# Access Compliance Report

## Public Rights-of-Way

Intersection ID: 10015273	Main Street: E_12TH_ST	Cross Street: N/A	Location: W
ADA ID: 42454068554A	Ramp Type: Perp	Initial Pass/Fail: Pass	Overall Compliance: No
		Severity Score: 0.25

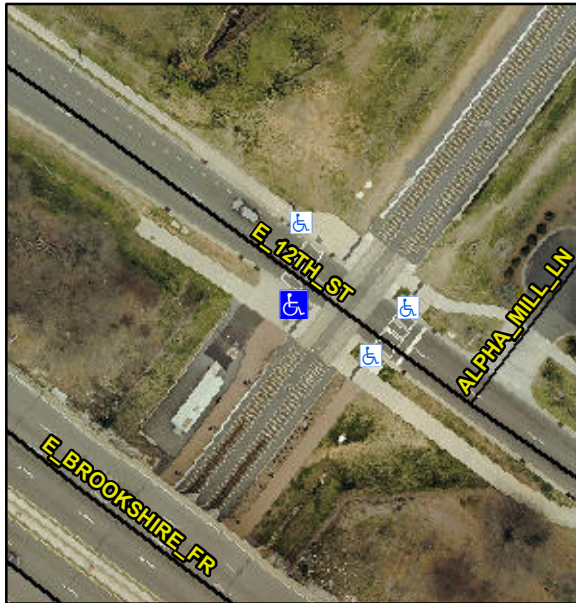
**Remove & Replace Entire Ramp.  
Utility Present.**

**R304.5.3, R302.3, R402.2**

Compliance	Description	Data	Compliance	Description	Data
N/A	Ramp Length (in)	95.0	Yes	Ramp Slope (%)	7.8
Yes	Ramp Width (in)	62.5	No	Ramp XSlope (%)	3.9
N/A	Flare Type LT	Sloped	N/A	Flare Type RT	N/A
N/A	Flare Slope LT (%)	4.4	Yes	Flare Slope RT (%)	1.6
N/A	Flare Traversable LT?	Yes	N/A	Flare Traversable RT?	Yes
Yes	Landing Length (in)	102.5	Yes	DWS Provided?	Yes
Yes	Landing Width (in)	59.5	Yes	DWS Contrast?	Yes
Yes	Landing Slope (%)	0.3	Yes	DWS Length (in)	24.0
Yes	Landing X Slope (%)	0.8	Yes	DWS Full Width?	Yes
N/A	Landing Curb? (Y/N)	No	Yes	DWS Offset (in)	0.0
N/A	Shared Landing?	No			
Yes	Gutter Ponding?	No	Yes	Gutter Slope (%)	1.3
Yes	Gutter Lip Ht (in)	0.0	Yes	Gutter X Slope (%)	2.1
N/A	Painted X Walk1?	No	N/A	Painted X Walk2?	N/A
	X Walk 1 Direction	To NE		X Walk 2 Direction	N/A
N/A	X Walk 1 Width (in)	N/A	N/A	X Walk 2 Width (in)	N/A
	X Walk 1 Slope (%)	1.3		X Walk 2 Slope (%)	N/A
	X Walk 1 X Slope (%)	2.1		X Walk 2 X Slope (%)	N/A

Possible Solutions:
